Town of Surfside

RFQ 2022-05

Construction of Town of Surfside 96th Street Park

Addendum No. 4

3 LOG CLIMBERS ON HILL - ENLARGEMENT PLAN
SCALE: 1" = 1'-0"

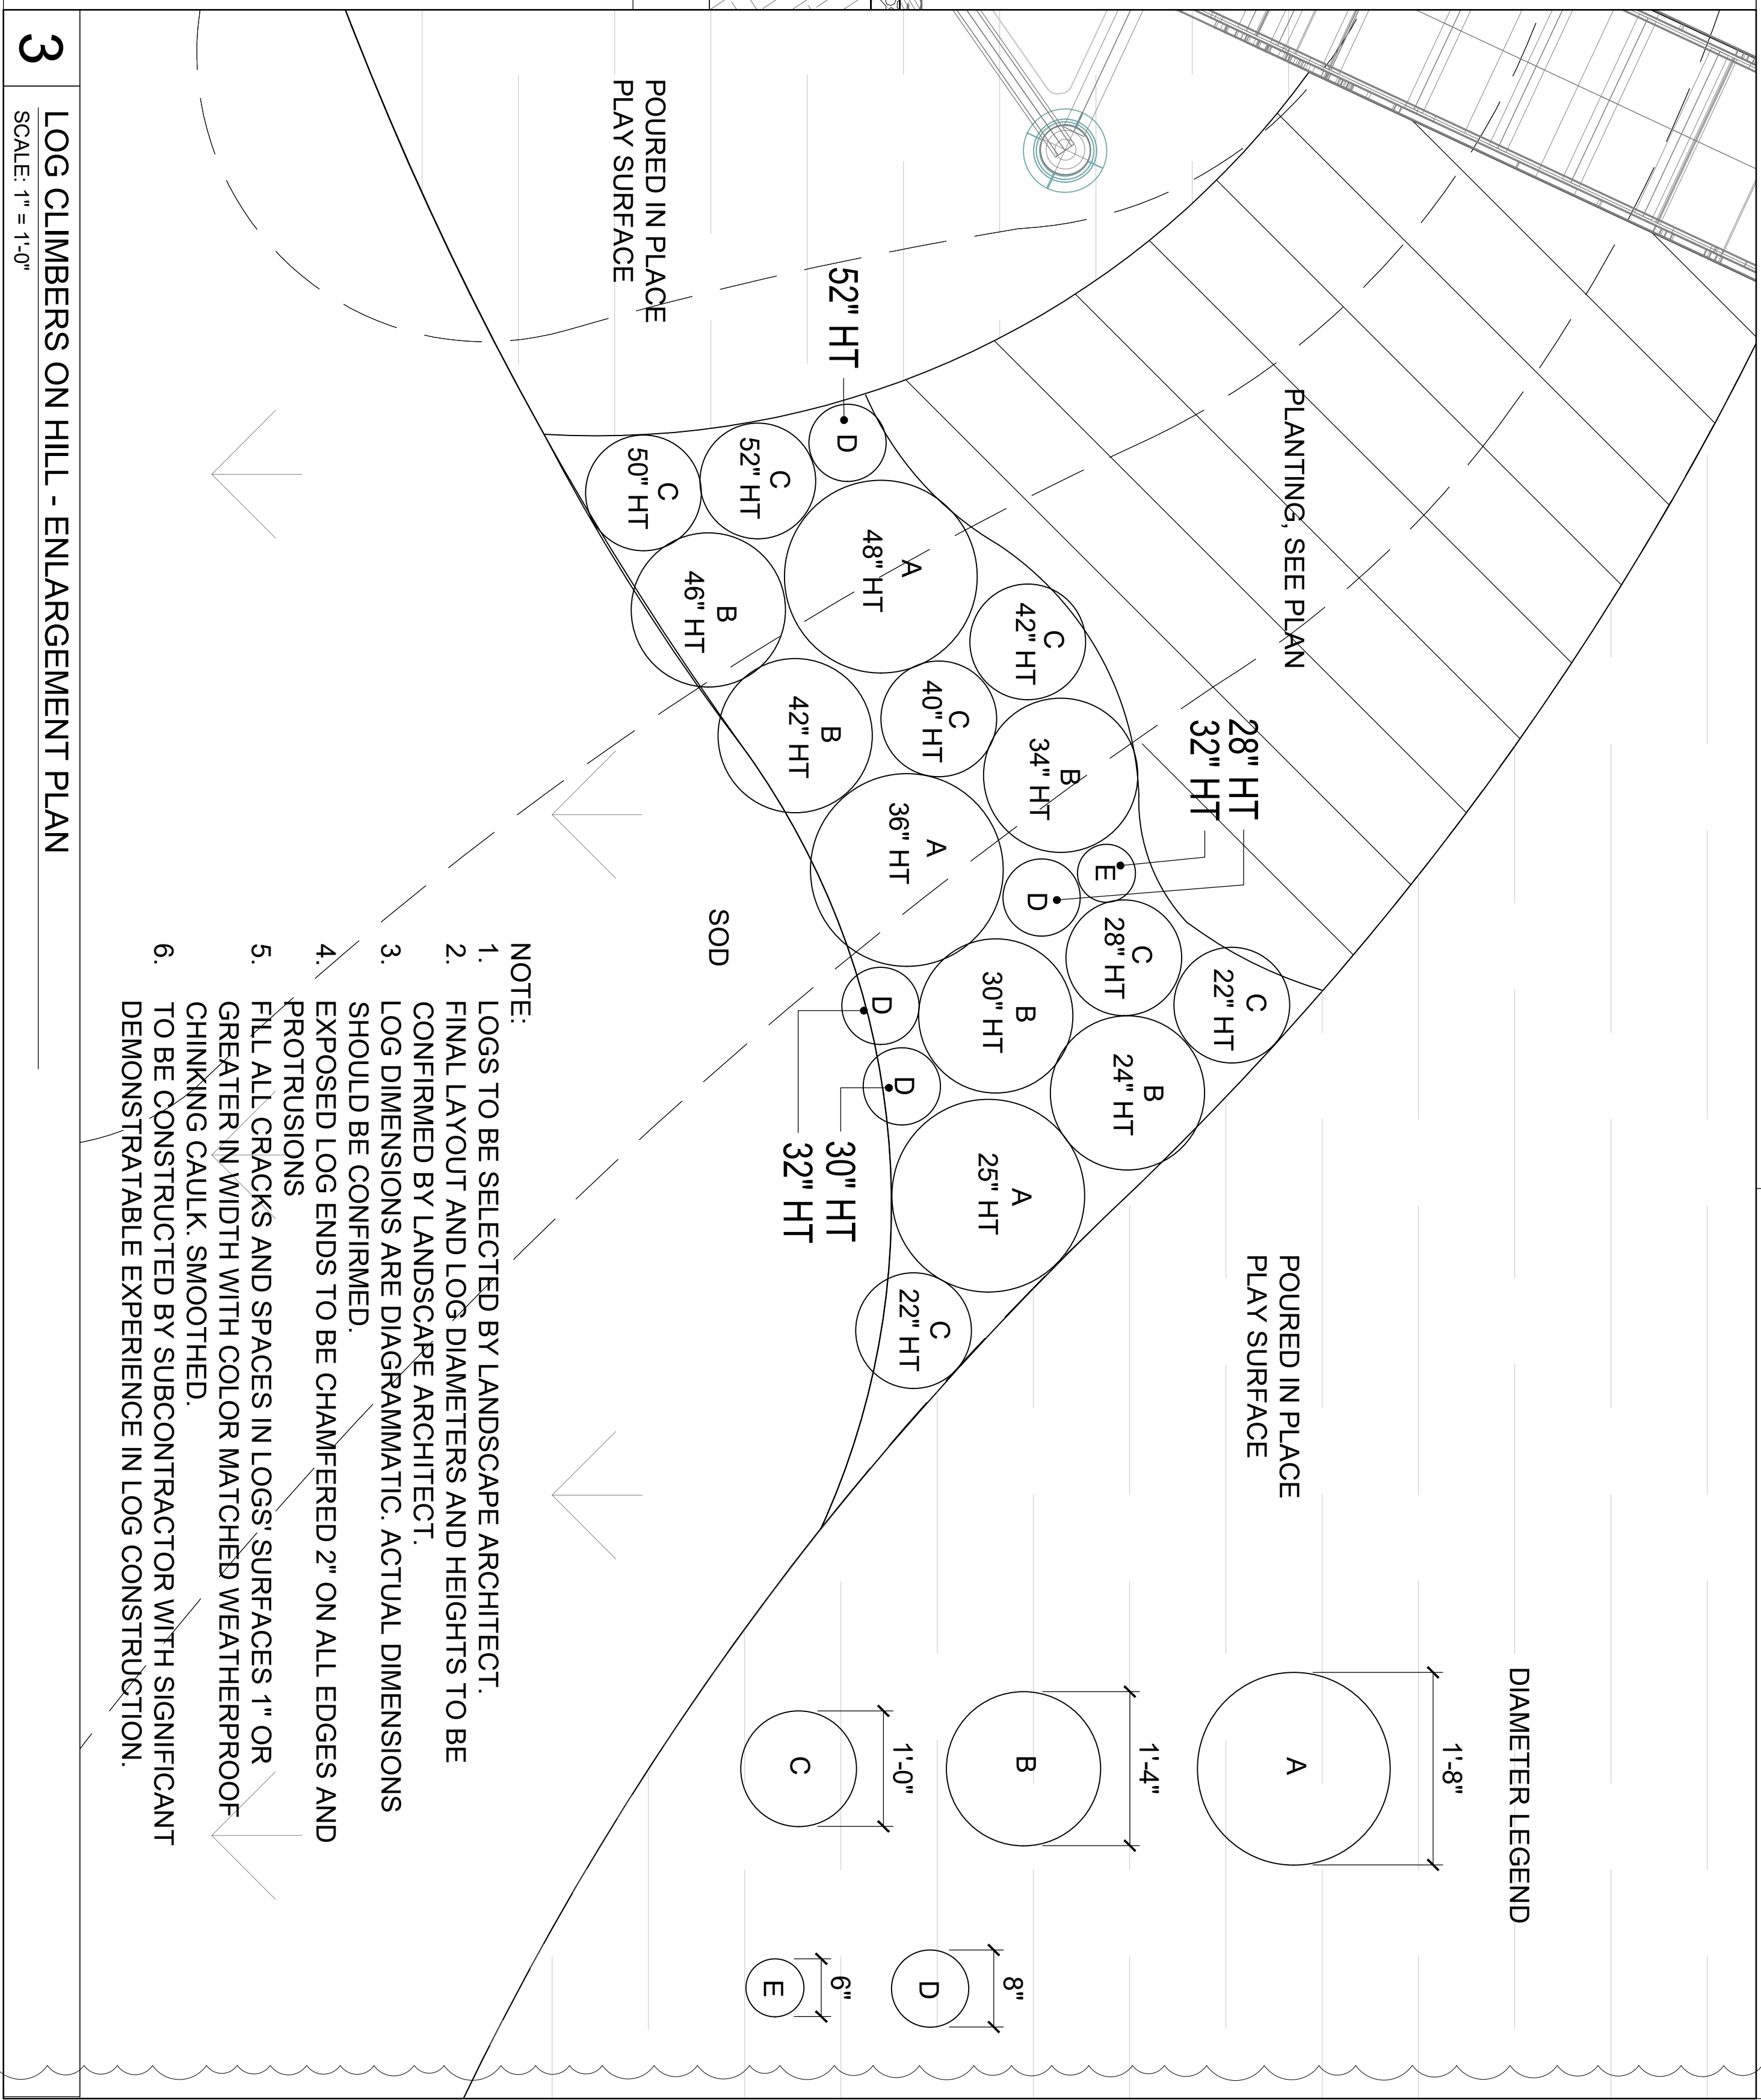
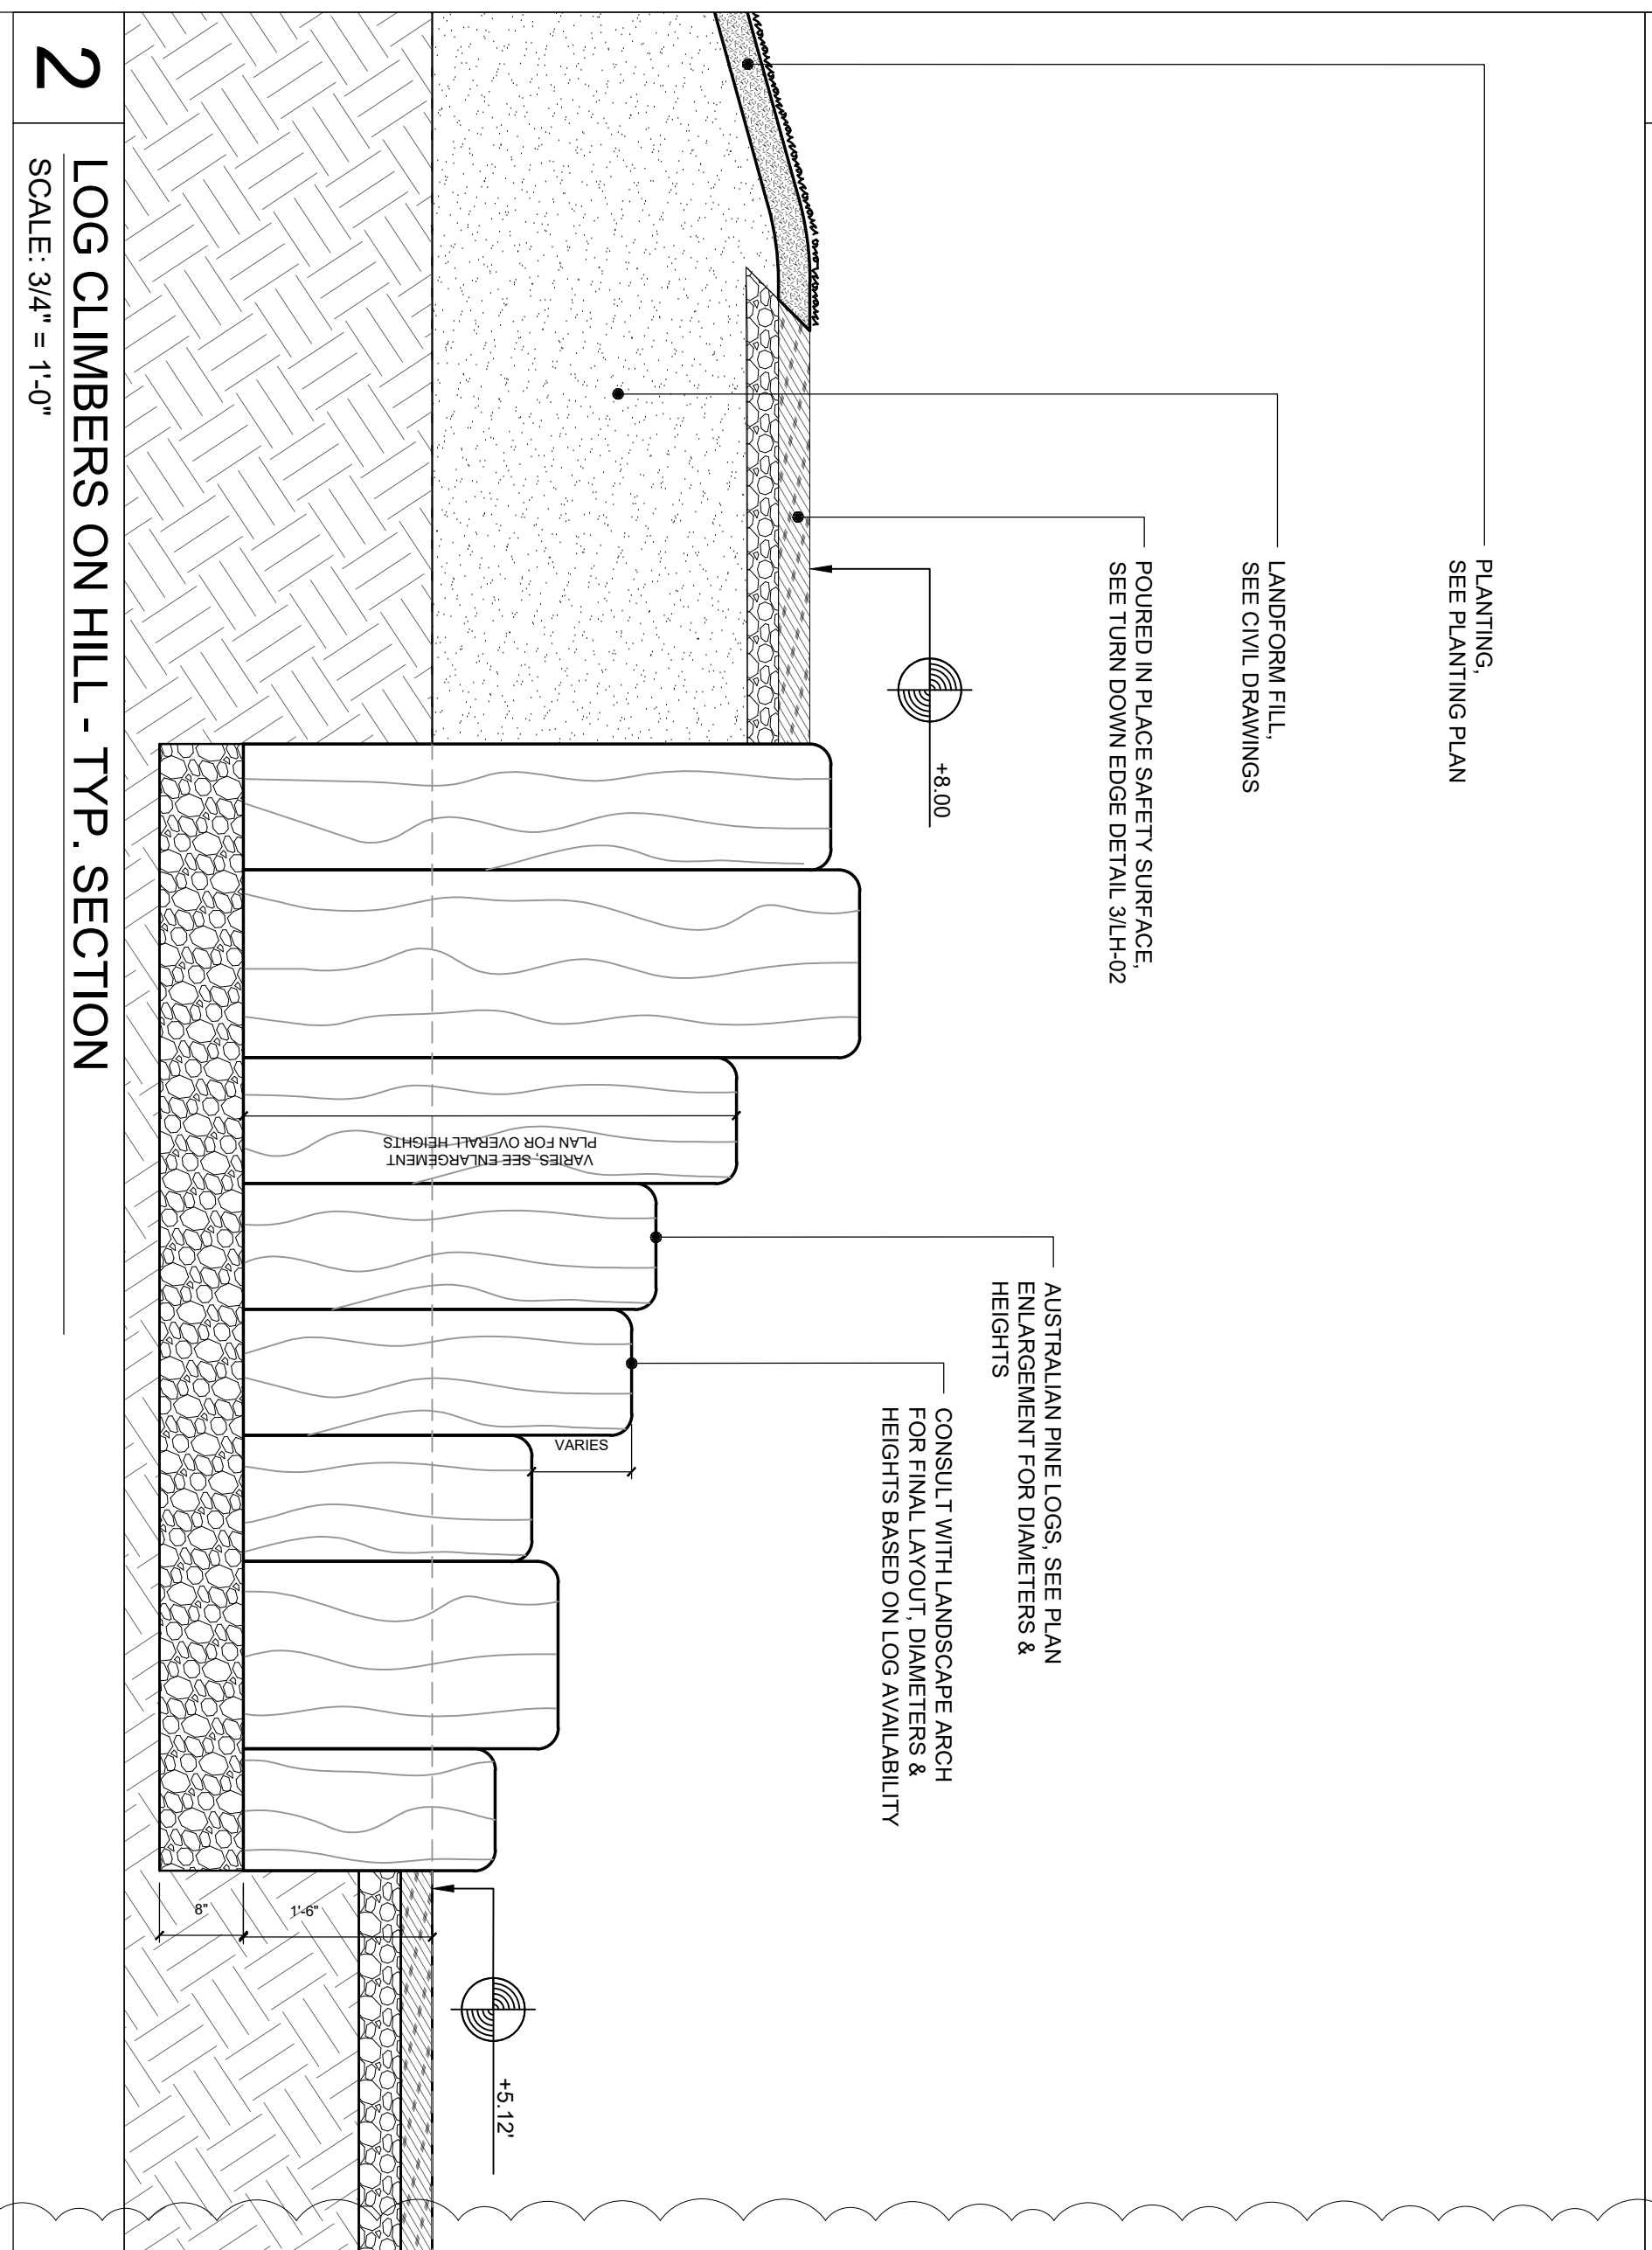
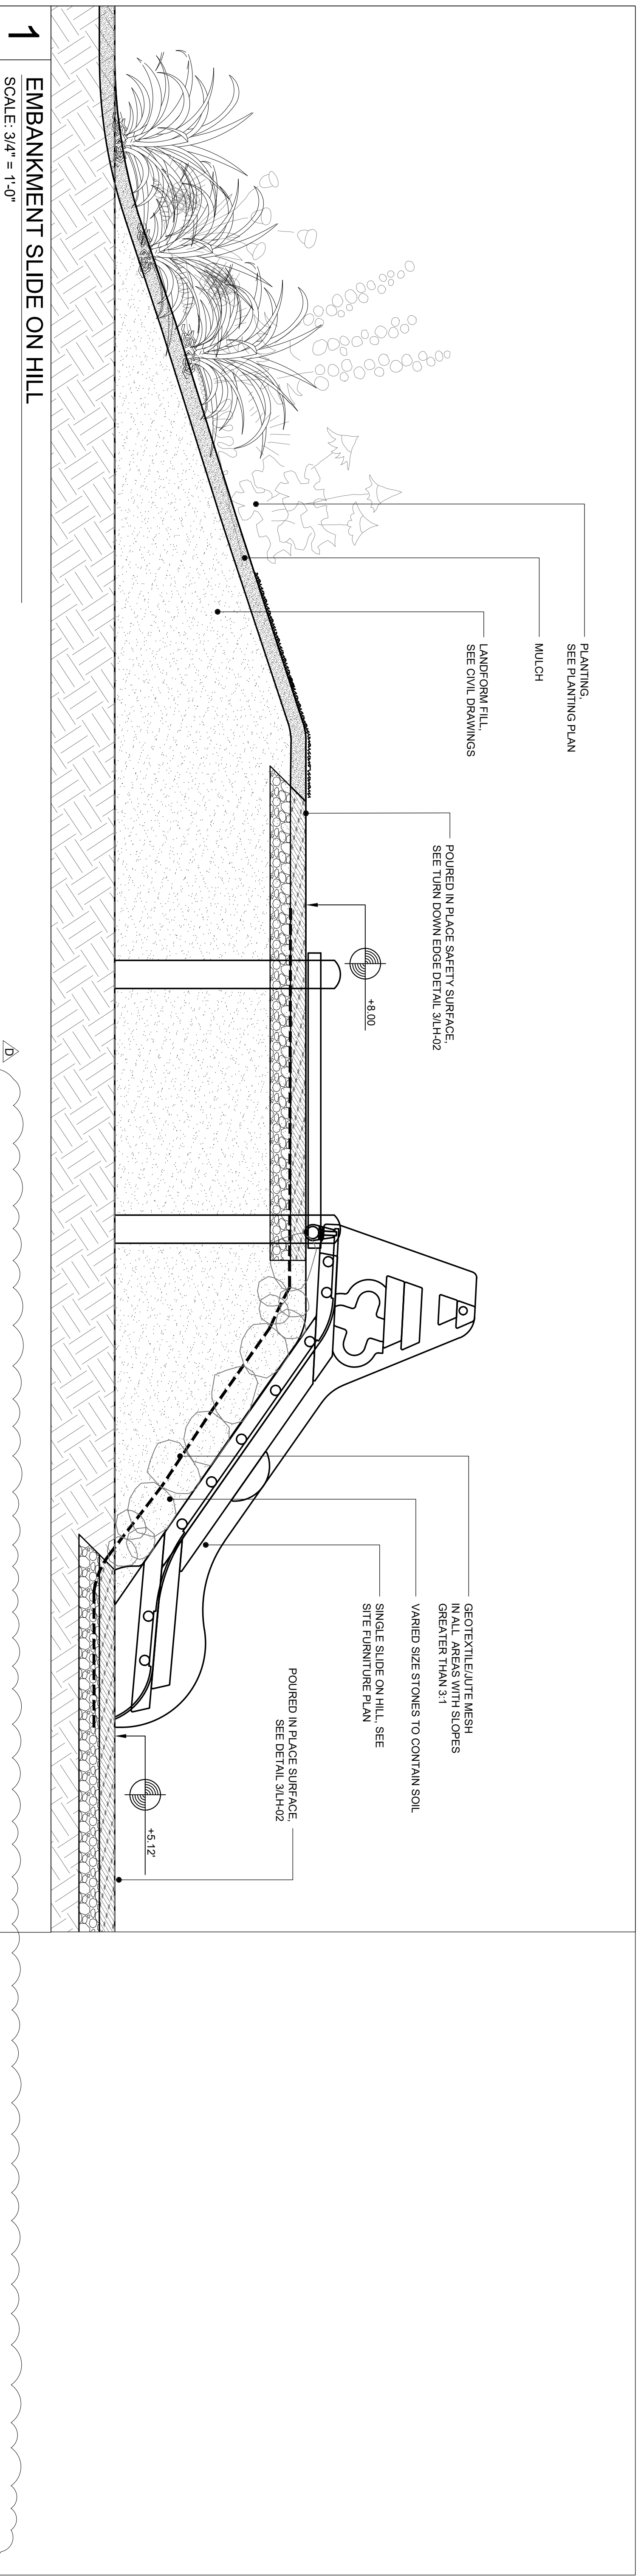
- 25. Please provide the dimensions, heights, and lengths of the proposed Sinker Cypress Logs.**

See updated enlargement plan on sheet LH-03, showing diameter and overall height for each log.
